STAFF REPORT: MARCH 12, 2025, REGULAR MEETING
APPLICATION NUMBER: HDC2025-00048
ADDRESS: 1817 LEVERETTE
HISTORIC DISTRICT: CORKTOWN
APPLICANT: ELISE DECHARD, END STUDIO
PROPERTY OWNER: ALLENSON, THOMAS E & MAUREEN T
DATE OF PROVISIONALLY COMPLETE APPLICATION: FEBRUARY 5, 2025
DATE OF STAFF SITE VISIT: FEBRUARY 28, 2025

SCOPE: DEMOLISH REAR PORCH, ERECT REAR ADDITION

Elevations of proposed work. Images from application.

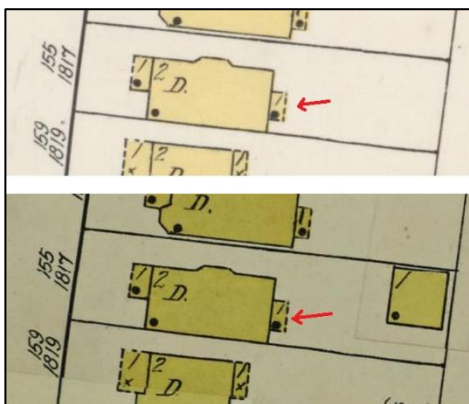
- Staff suggests that the overall form and massing of the proposed addition is consistent with the Elements

of Design and compatible with the building and the surrounding environment. One arguable exception is the expanse of unsupported, projecting shed roof over the east steps, a more modern design that would not have been employed during the period of significance (that a similar condition exists on the building presently is almost certainly a later alteration). However, staff opinion is that this is a relatively minimal aspect of the proposed addition's character and provides a degree of the "differentiation" called for by Standard #9.

- The proposed materials and colors are appropriate, with the exception of the aluminum siding. Though aluminum siding is found on the building presently, that would be a later twentieth century alteration and not a historic material. The Elements of Design (#7 and #8) suggest wood clapboard siding would be appropriate.

- The proposed addition uses aluminum siding, an inappropriate material. Wood clapboard should instead be specified.

- The siding shall be wood clapboard.
